**PLANNING**

project title	KOKO + Hope & Anchor + Bayham Place, Camden, London	scale	1:100	date	13.04.17
drawing title	Proposed Ground Floor Plan	drawn	FR/PC	checked	DA
drawing number	AHA/KCC/GA/100	revision			M

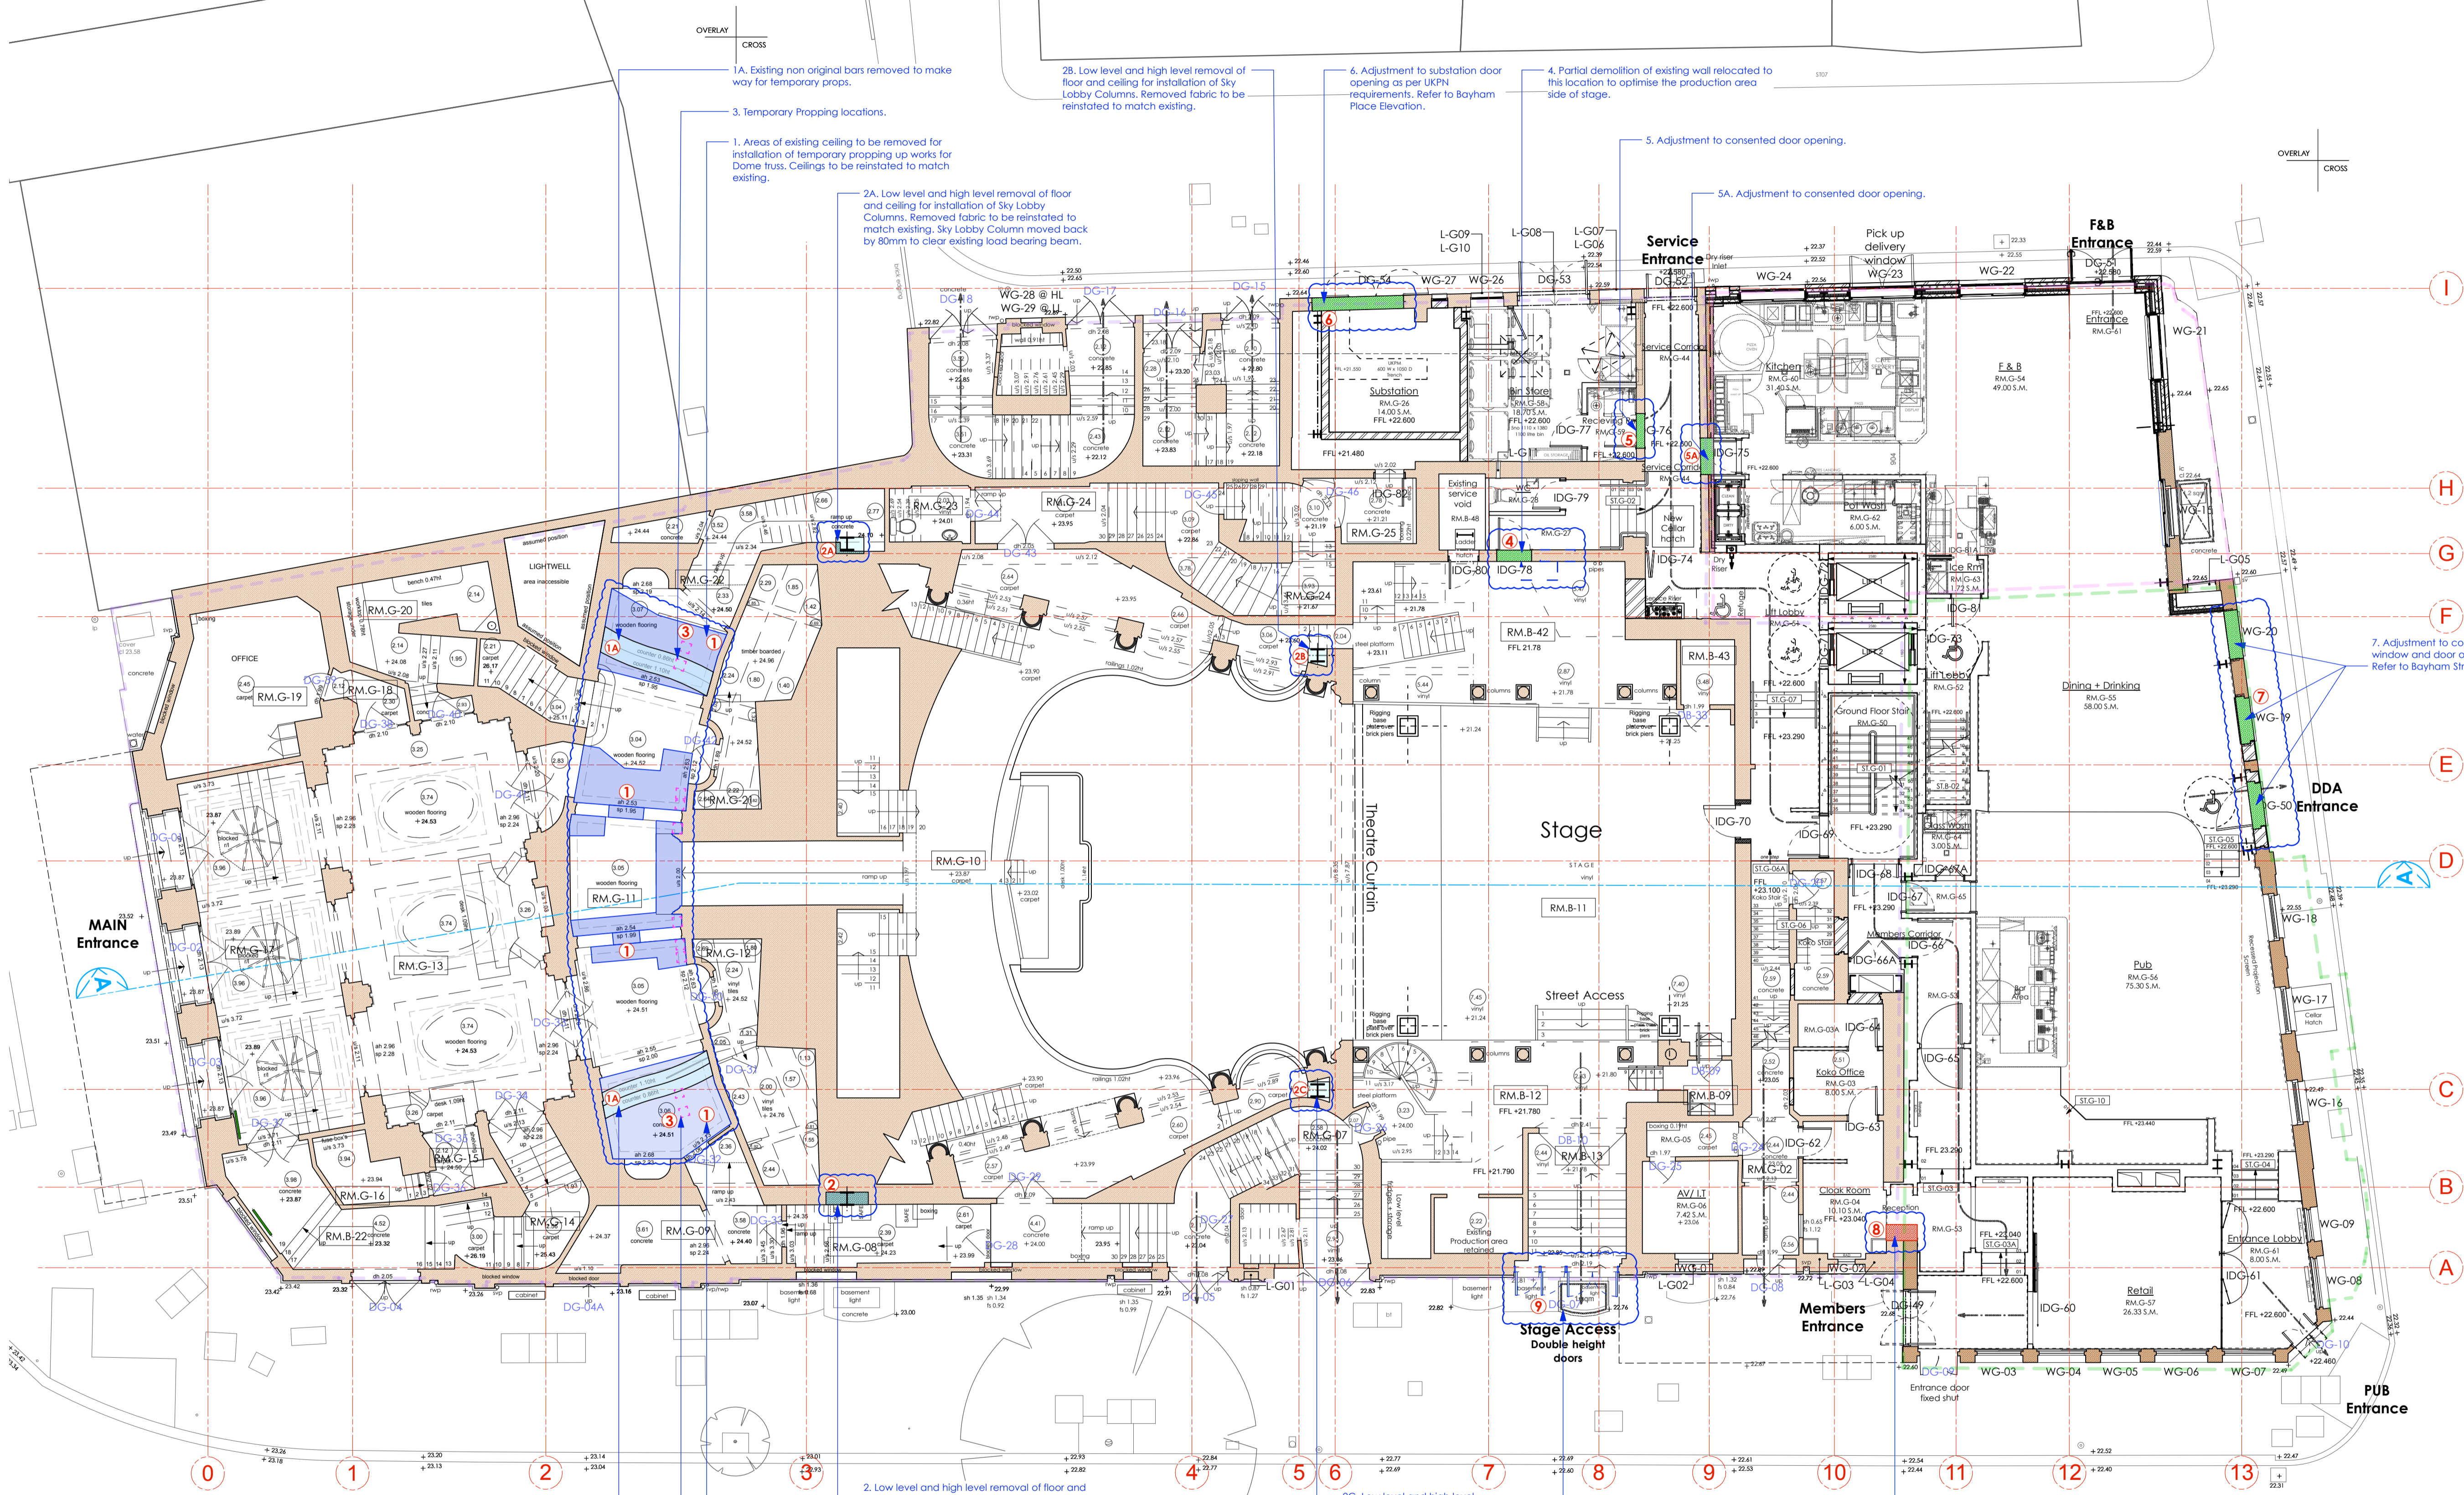
- / 26/01/18 / - First Issue
- A / 23/03/18 / 1. Tender Addendum (1). Indication of 4 post truss fixed at stage level for integrated automatic retractable acoustic baffles and integrated lighting rig.

- B / 12/04/18 / 2. Tender Addendum (2). New AHU + Attenuator over stage to be hung to existing relocated secondary beams in Flytower.
- C / 01/06/18 / - Door and window numbers updated  
Listed Building Application

1. Indication of 4 post truss fixed at stage level for integrated automatic retractable acoustic baffles and integrated lighting rig.  
2. New AHU + Attenuator over stage to be hung to existing relocated secondary beams in Flytower.

- D / 05/07/18 / 1. Updated stage 4 fit interior and kitchen layouts.
- E / 31/07/18 / G.2. Built-out column omitted on retail side  
G.7. Refer to Basement drawing. WCs vents to run through to roof and boxed out as part of joinery.  
G.8. Ventilation grille opening below window WG-26  
G.9. Basement Ventilation plant to Bin Store  
Colour coding added to revised drawing RevE  
Following sub-basement extension there is a requirement for smoke ventilation with a new smoke vent outlet on Bayham Street.

- F / 15/08/18 / G.22/01/19 / 1. Retrospective Planning for Dome Propping up works. Ref: 2019/0695/L  
Proposed Dome Truss LBC Application  
Proposed Dome LBC Application for 1. Permanent Dome Truss.

- H / 29/01/19 / 2. Dome Front Pier PFCs.  
3. Replacement of Dome Copper Roof
- K / 30/10/19 / 1. Following review of PFC location, PFCs to be chased into wall and concealed.  
Retrospective Planning for removal of listed fabric around temporary propping up works for Dome Truss.

- L / 01/11/19 / Retrospective planning application for:  
1. Removal and reinstatement at high level H/L.  
2. Removal and reinstatement of low level L/L.

3. Removal of and reinstatement of walls  
4. Removal of walls.  
5. Change to consented proposal.  
Refer to colour coded legend and annotations 1-9.
- M / 11/02/2020 /
